City of Albuquerque

Environmental Health Department

To: Regan Eyeran, Environmental Health Scientist
From: Jeff Stonesifer, Senior Environmental Health Scientist *JS*
Subject: Review of model for Albuquerque Metals Recycling, Inc.
Permit # 1529-M3

Albuquerque Metal Recycle 20MM4C 11.41 Permit Modeling Mod C:\DispModeling\Sources\ABQ Metals Recycling\1529-M3\fourth review\AMRTSP 24 HR080316_syrs_TSP.GRF

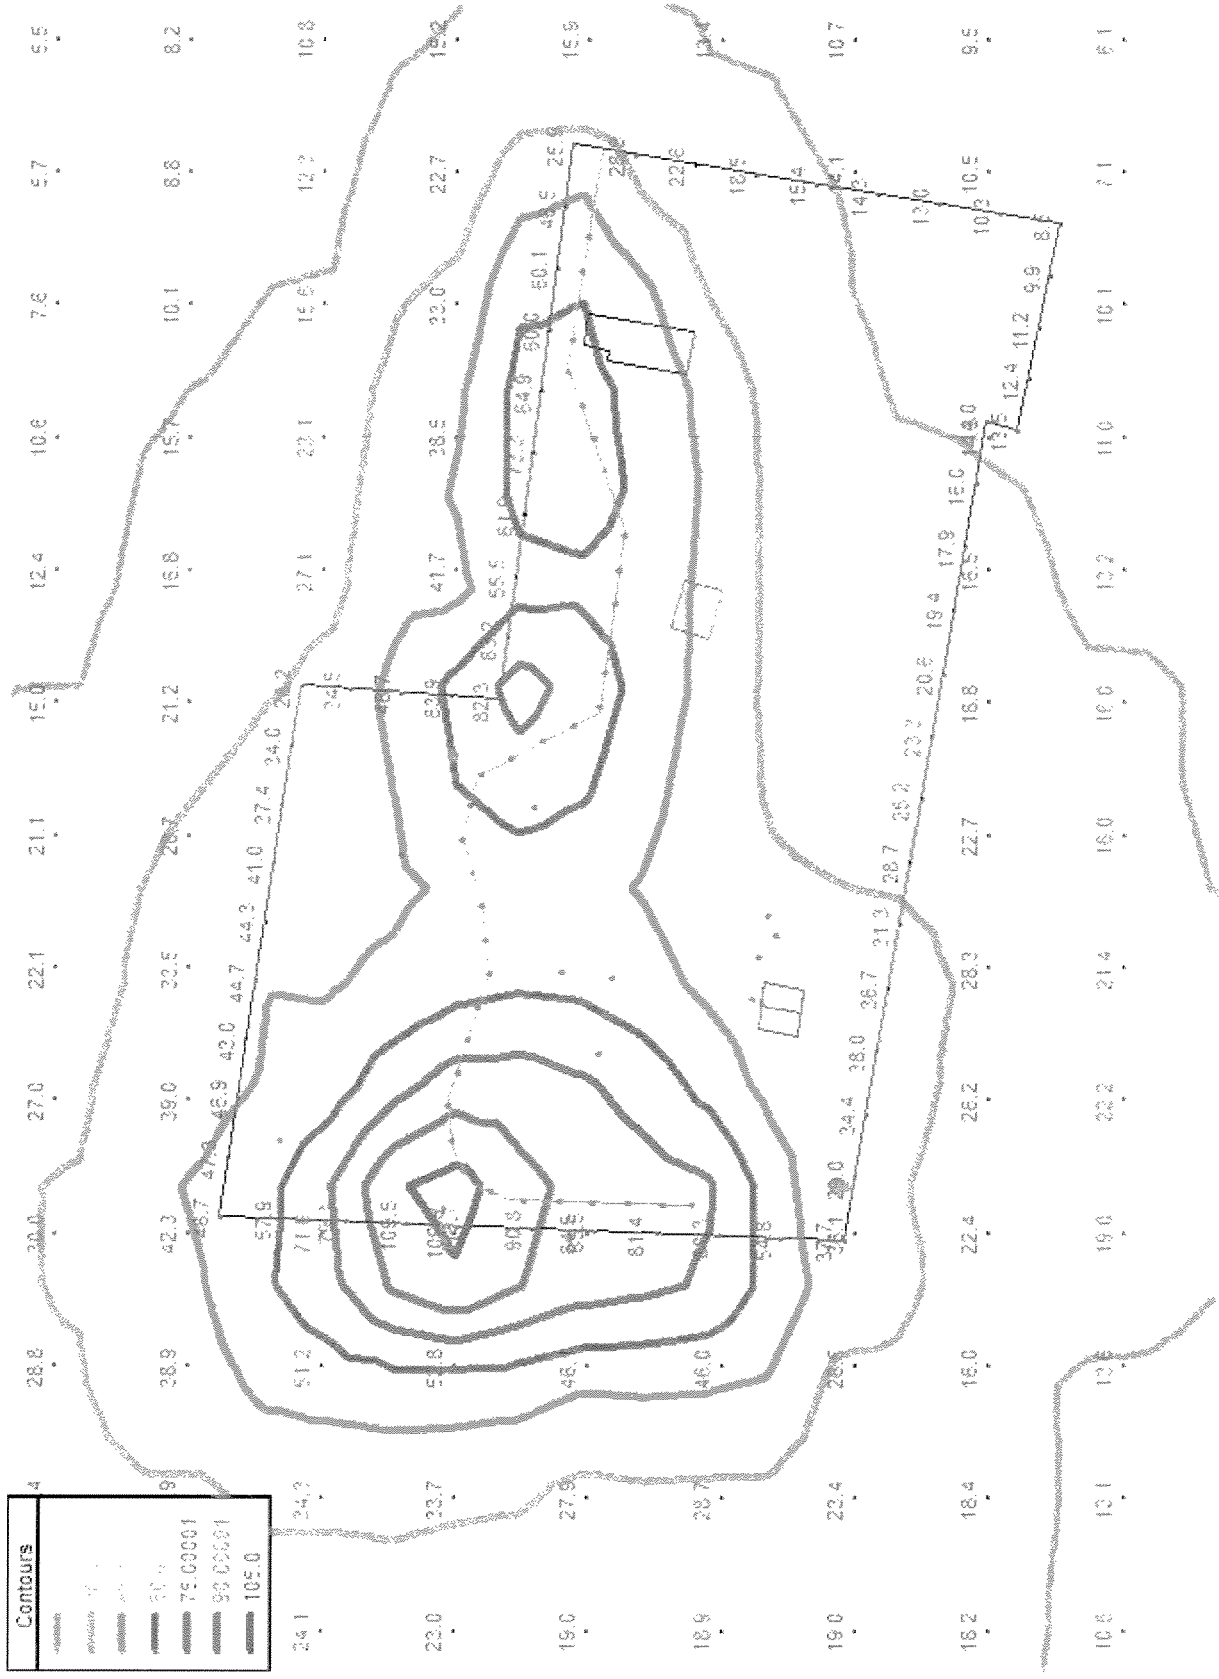
The inclusion of the motorhouse building resulted in slightly higher results along the southwestern fenceline of the property. However the modeling still passed all applicable ambient air quality standards.
